Safety Advice

Robel Orbital Hand Tamper Failure - Remedial Action

Ref: NRA 15/09 Update 1

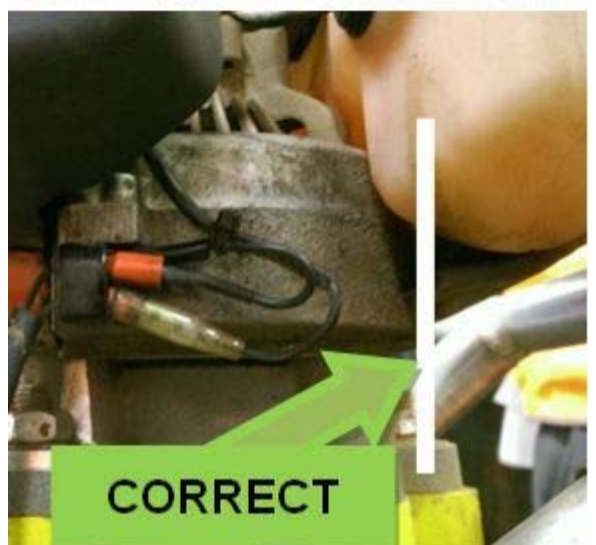
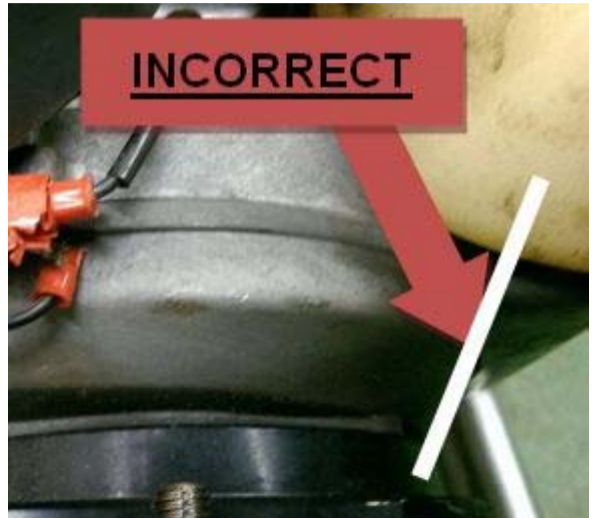
The **incorrect** fan housing can be identified by its sloping diagonal sides located on the base of the fan housing. This equipment must be removed from service, quarantined and returned to Torrent or Robel, dependent upon who owns the product.

The **correct** fan housing can be identified by its vertical side extending to the base of the fan housing. Some of these variants are also manufactured in polished aluminium. These units may be returned to service and used in accordance with standard operational procedures and pre-use inspections.

- All 62.05 machines fitted with the incorrect fan housing, identified by its sloping diagonal sides located on the base of the fan housing, must not be used and must be removed from service, quarantined and returned to Torrent or Robel for rectification.
- All 62.05 machines fitted with the correct housing and all 62.05HY variants may return to service when used in accordance with standard operating procedures.
- If you are in doubt about whether the equipment is safe to use do not use it and seek assistance as below.
